RE: **428 Lafayette Road**

428 LAFAYETTE ROAD  
Hampton, New Hampshire

PROJECT	428 LAFAYETTE ROAD HAMPTON, NH	SCALE	1"
TITLE	COVER SHEET	PROJECT	5
		DRAWING	C
		SHT.	1

**Subject:** 428 Lafayette Road, Plan Review Items

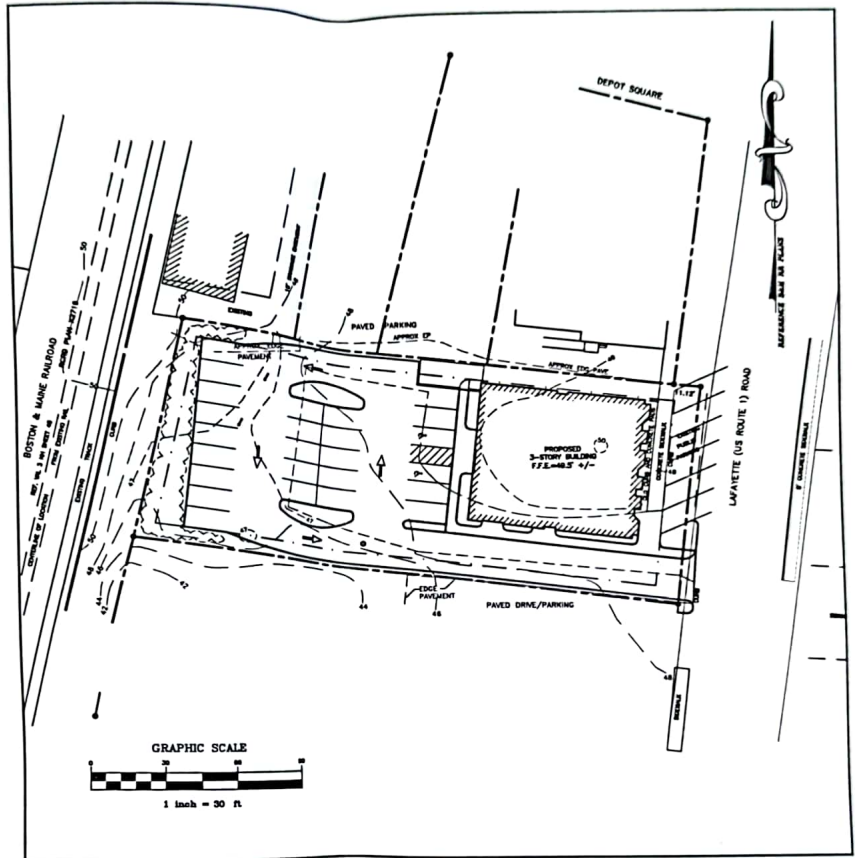
4. Does the dumpster area have to be that big?
5. Could we please substitute USGS Quad sheet for location plan on the cover sheet? What you have on there now looks, well, awful.

8. I have a typo on tax map 160 lot 7. My apologies, and could you please fix it?
9. The legend on the cover sheet appears pretty unrelated to the actual plans. Could somebody look at that?

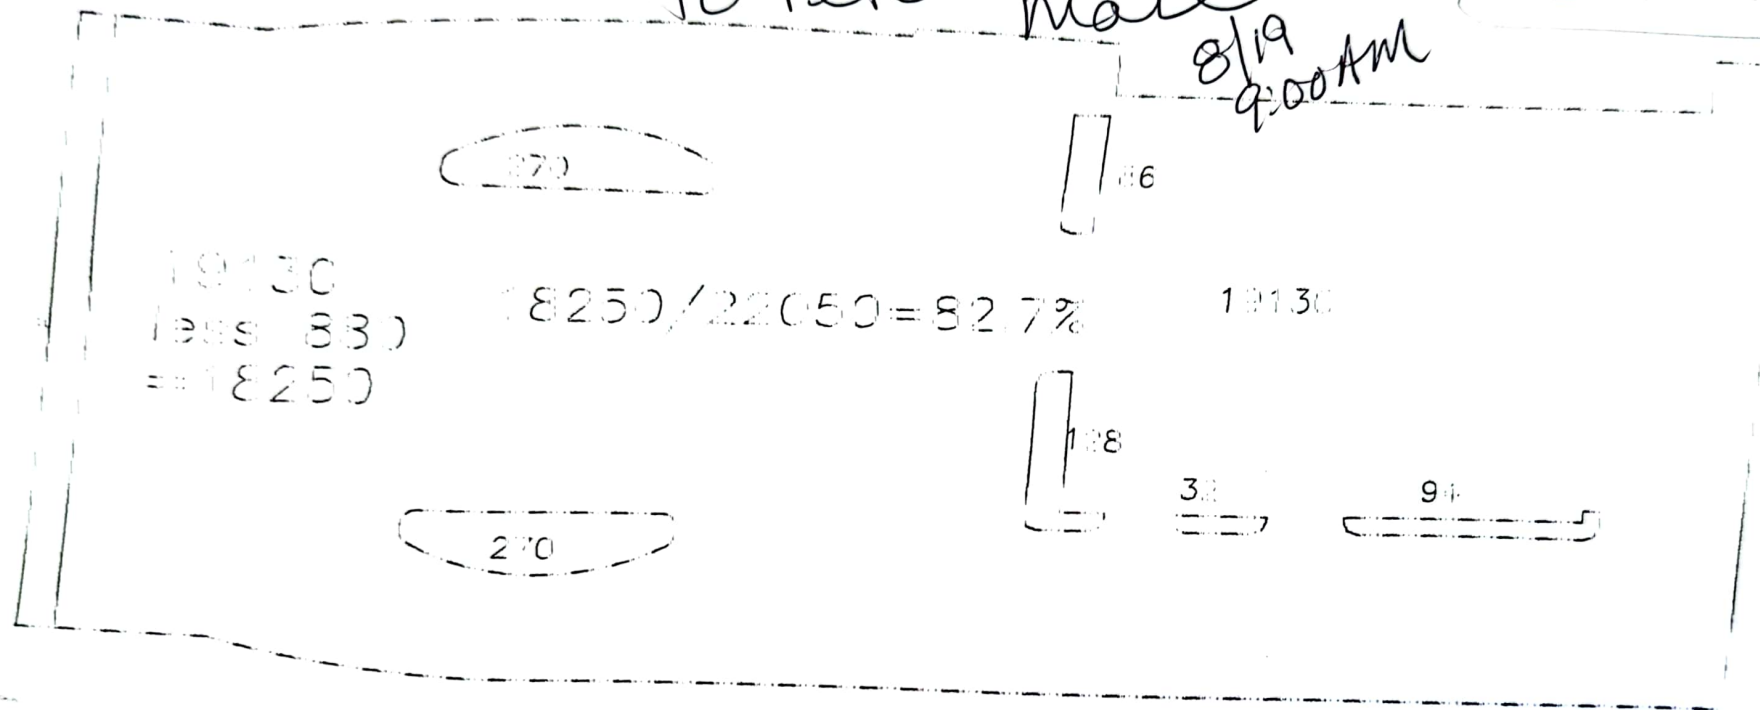
arent sewer and water supposed to be 10' apart???

why the 90' bend???

we are screwing with the chutters driveway!!!

invented woods @ rear of lot?
